Airworthiness Directives; Eurocopter France Model AS-365N2, AS 365 N3, EC 155B, EC155B1, SA-365N, N1, and SA-366G1 Helicopters

ACTION: Notice of proposed rulemaking (NPRM).

SUMMARY: This document proposes to revise an existing airworthiness directive (AD) for Eurocopter France (Eurocopter) Model AS-365N2, AS 365 N3, EC 155B, EC155B1, SA-365N, N1, and SA-366G1 helicopters. That AD currently requires inspecting the main gearbox (MGB) base plate for a crack and replacing the MGB if a crack is found. This action would increase the

Figure 1

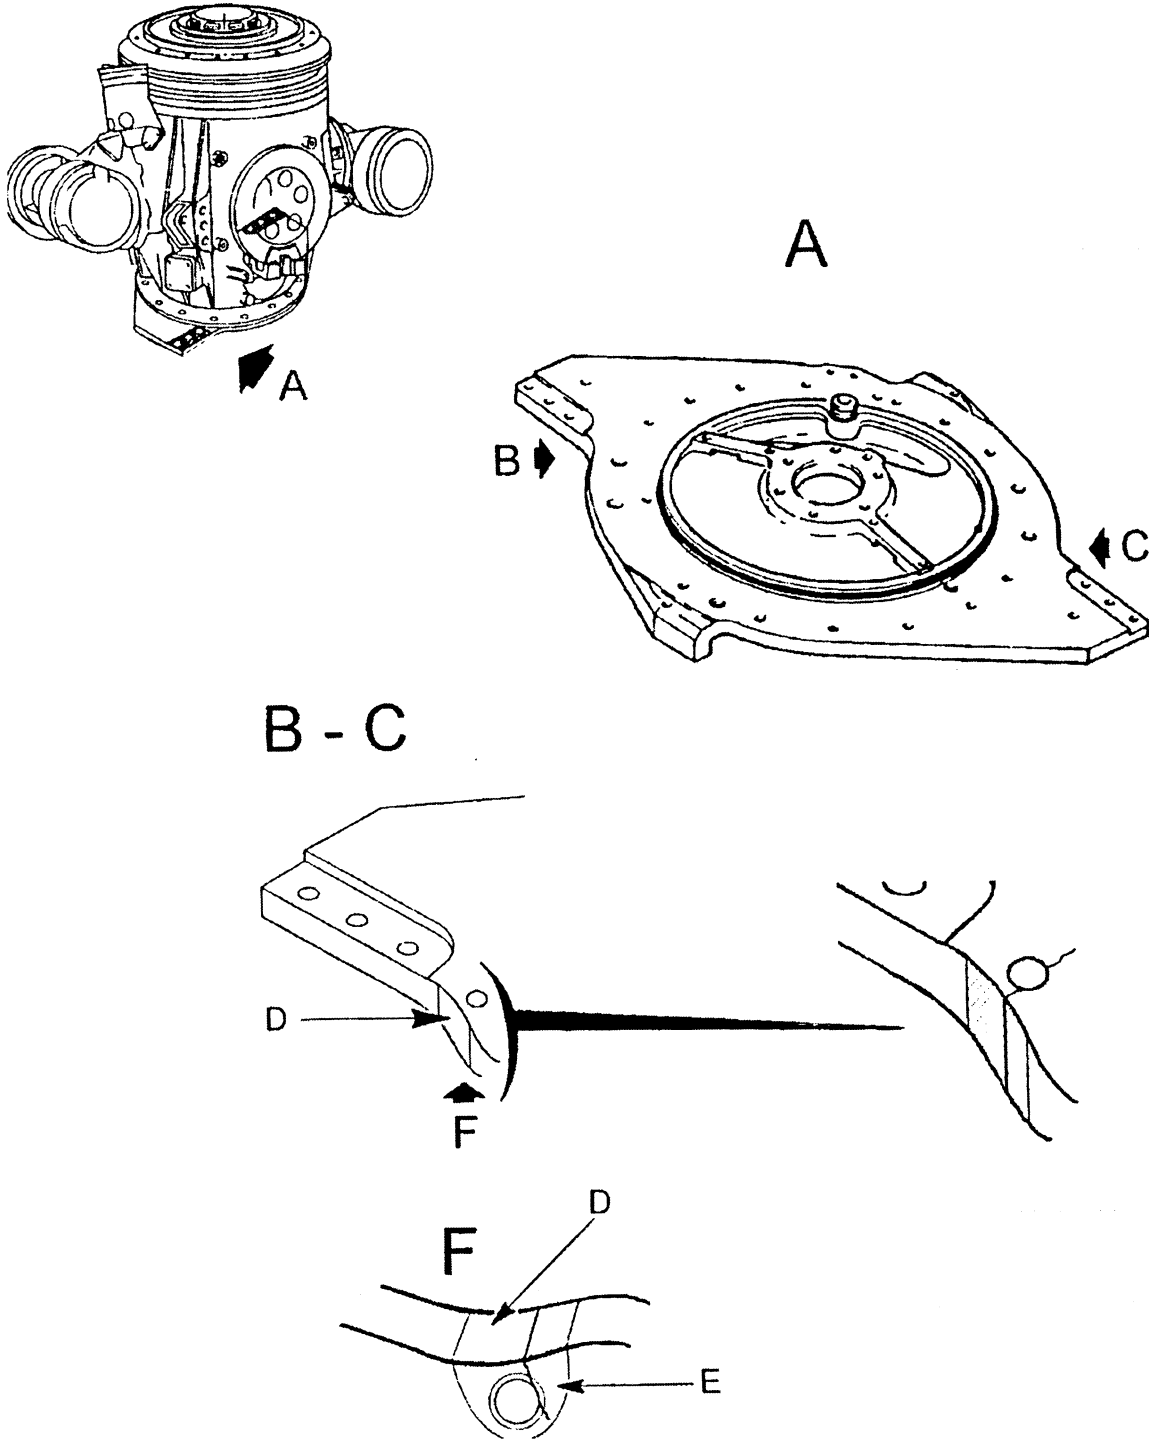
strip the paint from area "D" on both sides ("B" and "C") of the MGB base plate as depicted in Figure 1 of this AD.

(b) At the times indicated in the compliance table, inspect area "D" of the MGB base plate for a crack using a 10x or higher magnifying glass. Area "D" to be inspected is depicted in Figure 1 of this AD.

(c) If a crack is found in a MGB base plate, remove and replace the MGB with an airworthy MGB before further flight.
